APPLICATION NO.	FILING DATE	FIRST NAMED INVENTOR	ATTORNEY DOCKET NO.	CONFIRMATION NO.
10/699,648	11/04/2003	Naoya Ishikawa	953.1012	5367
21171	7590	08/15/2005	EXAMINER	
STAAS & HALSEY LLP SUITE 700 1201 NEW YORK AVENUE, N.W. WASHINGTON, DC 20005			TRIEU, THAI BA	
			ART UNIT	PAPER NUMBER
			3748

Office Action Summary

DETAILED ACTION

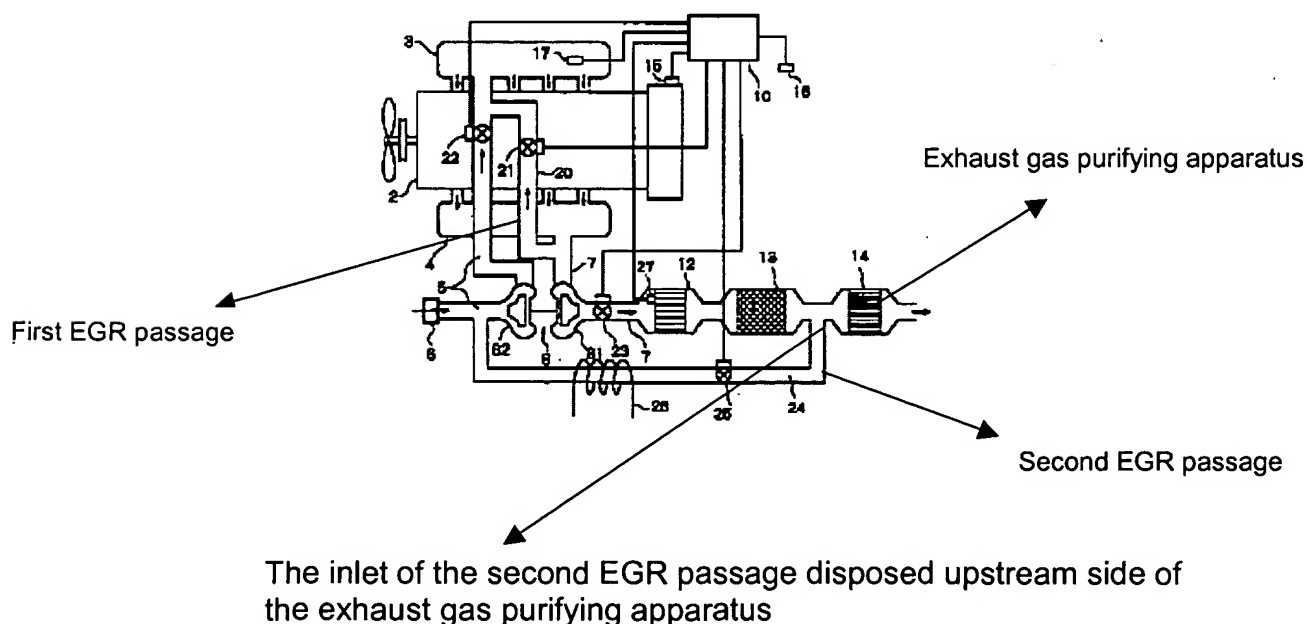
Minami discloses an EGR system for an internal combustion engine (2) with a turbocharger (8), comprising a first EGR passage (Not Numbered, Read as a passage including valve 21) for recirculating a part of the exhaust gas from the upstream side of a turbine (81) of the turbocharger (8) to the downstream side of a compressor (82) of the turbocharger;

wherein a second EGR passage (24), comprising an inlet (Not Numbered), for recirculating a part of the exhaust gas from the downstream side of said turbine (81) to the upstream side of said compressor (82), a flow control means (21) for controlling the exhaust gas in said first EGR passage (Read as a passage including valve 21) and said second EGR passage (24), an exhaust gas purifying apparatus (14), an EGR control means (25) for controlling the flow control means based on data detected by an exhaust gas state monitoring means are provided;

wherein the second EGR passage being branched out on an upstream side of the exhaust gas purifying apparatus, and the inlet of the second EGR passage is disposed upstream side of the exhaust gas purifying apparatus (14) (See Figure 1, Paragraphs from [0025] to [0028]);

wherein the flow control means being composed of the first EGR valve (21) arranged in said first EGR passage and the second EGR valve (25) arranged in said second EGR passage, and the EGR control means (10) controls the exhaust gas flow by controlling said first EGR valve (21) and said second EGR valve (25) to be open/closed said exhaust gas state monitoring means being composed of an exhaust gas temperature sensor arranged in said exhaust passage, and the EGR control means controls the exhaust gas flow by controlling said first EGR valve and said second EGR valve to be open/closed based on the exhaust gas temperature detected by the exhaust gas temperature sensor (See Figure 1, and Paragraphs [0012] and [0013]); and

wherein when said exhaust gas detection temperature is not higher than the regeneration temperature of said diesel particulate filter, said first EGR valve is controlled to be open, while said second EGR valve is controlled to be closed, and when said exhaust gas detection temperature is higher than the regeneration temperature of said diesel particulate filter, said second EGR valve is controlled to be open (See Paragraphs [0012], [0013], [0014], [0015], [0016], and [0017]).

However, Minami fails to disclose the location of the diesel particulate filter being in the second EGR passage after the second EGR passage is branched out of the main exhaust gas passage; and the exhaust gas purifying apparatus comprising the diesel particulate filter and NOx purifying catalyst converter.

EGR passage disposed upstream
side of the turbine

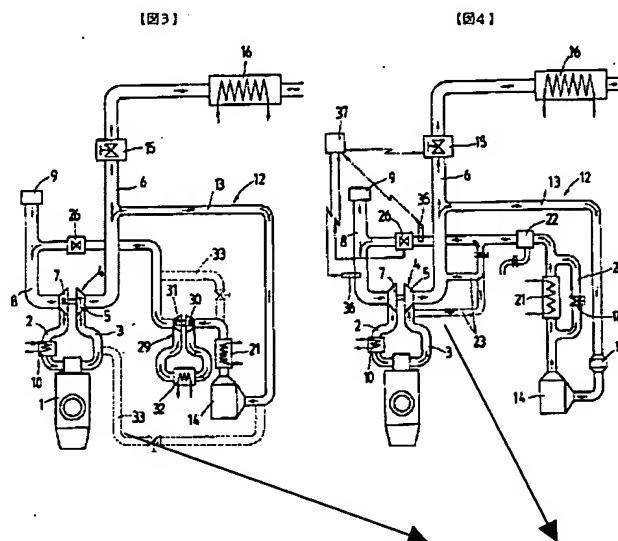
The modified Minami discloses the invention as recited above; however, fails to disclose an inlet of the second EGR passage being arranged at the upstream side of said turbine.

Yasuma teaches that it is conventional in the turbocharged internal combustion engine art, to utilize an inlet of the second EGR passage being arranged at the upstream side of said turbine (via 33, 14, 30, 29, 31, 26, 8) (See Figures 3, 4, and 6).

It would have been obvious to one having ordinary skill in the art at that time the invention was made, to have utilized an inlet of the second EGR passage being arranged at the upstream side of said turbine, as taught by Yasuma, to improve the reduction of exhaust emissions, in the modified Minami diesel engine.
